Office Action Summary	Application No.	Applicant(s)	
	10/527,491	YANAGIMOTO, OSAMU	
	Examiner	Art Unit	
	Sara Addisu	3722

DETAILED ACTION

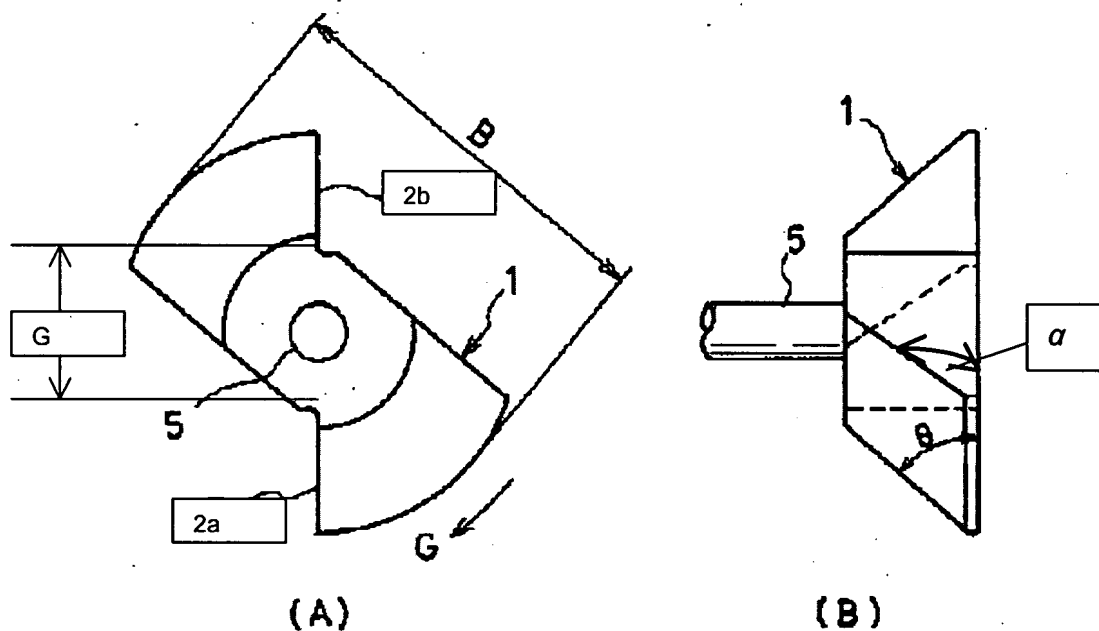
Regarding claims 1 and 3, '916 teaches a chamfering tool having a cutting section having an outer surface which is formed by a curved surface, the outer surface having a first blade section (2a: see below) which is tilted (by an angle α) so that a chip

is discharged to one side of the edge, and a second blade section (2b) which is tilted so that the chip is discharged to the other side different from the former side in a sliding direction of the cutting section with a gap (G) ('916, figures 1, 3, 9). Regarding claims 2 and 4, '916 teaches the first and second blades having cutting face (3) tilted so as to face one side of the edge ('916, figure 2a. note that figure 2 shows only one blade but figure 9 is another embodiment with two blades). Furthermore, regarding claims 3 and 4, teaches in figures 3-6, said chamfering tool having a shank section that is attached to a rotational chuck on the opposite side of the cutting section. Regarding claims 5-8, '916 teaches the first blade section (2a) and the second blade section (2b) being formed alternately in the peripheral direction of the outer peripheral surface while being symmetrical with respect to a rotating center axis of the cutting section ('916, figure 9a).
